[Docket No. 99-SW-81-AD]

Airworthiness Directives; Sikorsky Aircraft-manufactured Model CH-54A Helicopters

ACTION: Notice of proposed rulemaking (NPRM).

Siller Helicopters; Aviation International Rotors, Inc. (Air, Inc); Columbia Helicopters, Inc.; Chet Raspberry, Inc. (CRI); Silver Bay Logging, Inc.: Docket No. 99-SW-81-AD. Supersedes AD 99-07-16, Amendment 39-11102, Docket No. 97-SW-60-AD.

Rework of Second Stage
Lower Planetary Plate (6435-20229-102)
Figure 1

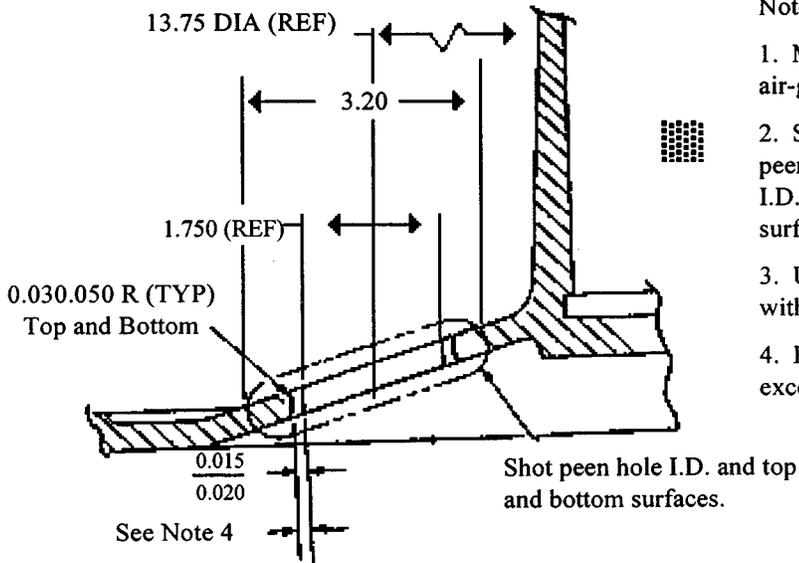
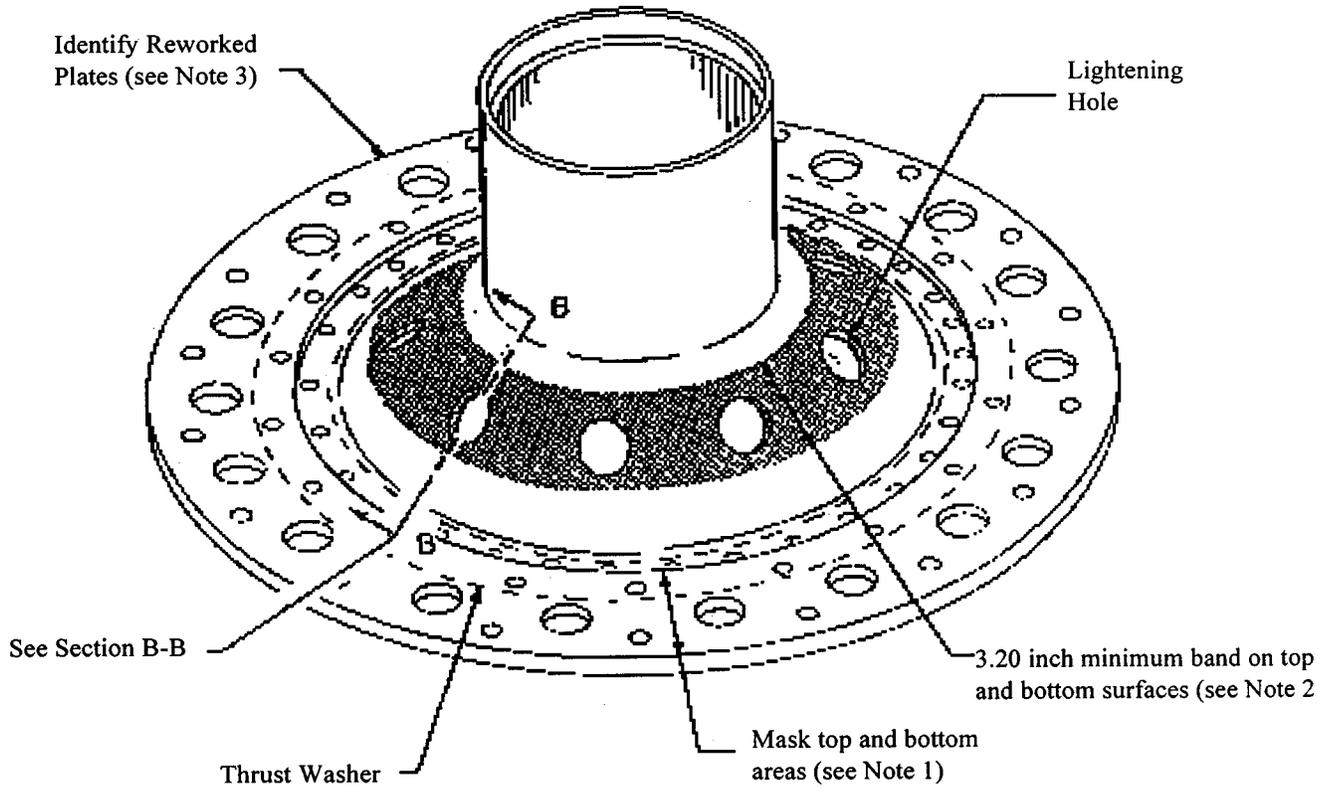
(i) Locate the center of each 1.750 inch-diameter lightening hole and machine holes 0.015 to 0.020 oversize on a side (0.030 to 0.040 diameter oversize). Machined surface roughness must not exceed 63 microinches AA rating (see Figure 1).

(ii) Radius each hole 0.030 to 0.050 inches on each edge as shown in Figure 1.

(iii) Mask the top and bottom surfaces of the plate to expose 3.20 inch minimum width circumferential band as shown in Figure 1.

(viii) Identify the reworked plate by adding "TS-107" after the part number using a low-stress depth-controlled impression-stamp with a full fillet depth of not more than 0.003 inch (see Figure 1).

1. Mask top and bottom areas to protect from liquid air-grit and shot peen.
2. Shaded area to be liquid air-grit blasted and shot peened includes plate top and bottom surfaces and I.D. of all lightening holes. Feather shot peened surface edges.
3. Use low-stress depth controlled impression-stamp with full fillet depth of no more than 0.003 inch.
4. Reworked machined surface roughness shall not exceed 63 microinches AA rating.

Borecope Inspection of
Second Stage Lower Planetary Plate
Figure 2

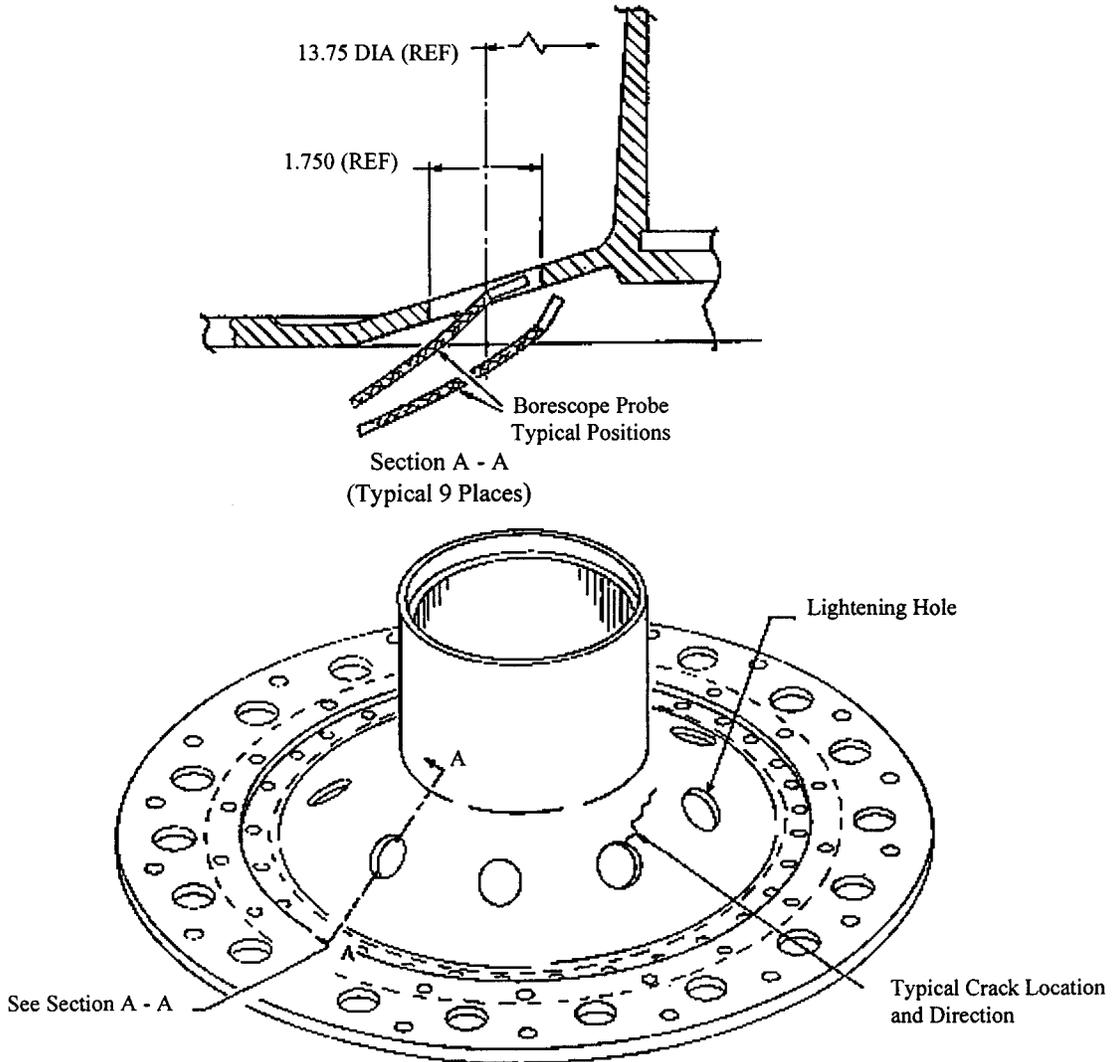
- (1) Inspect the plate for a crack in the area around all nine lightening holes using a Borescope or equivalent inspection method (see Figure 2).
- (2) If a crack is found, replace the plate with an airworthy plate prior to further flight.
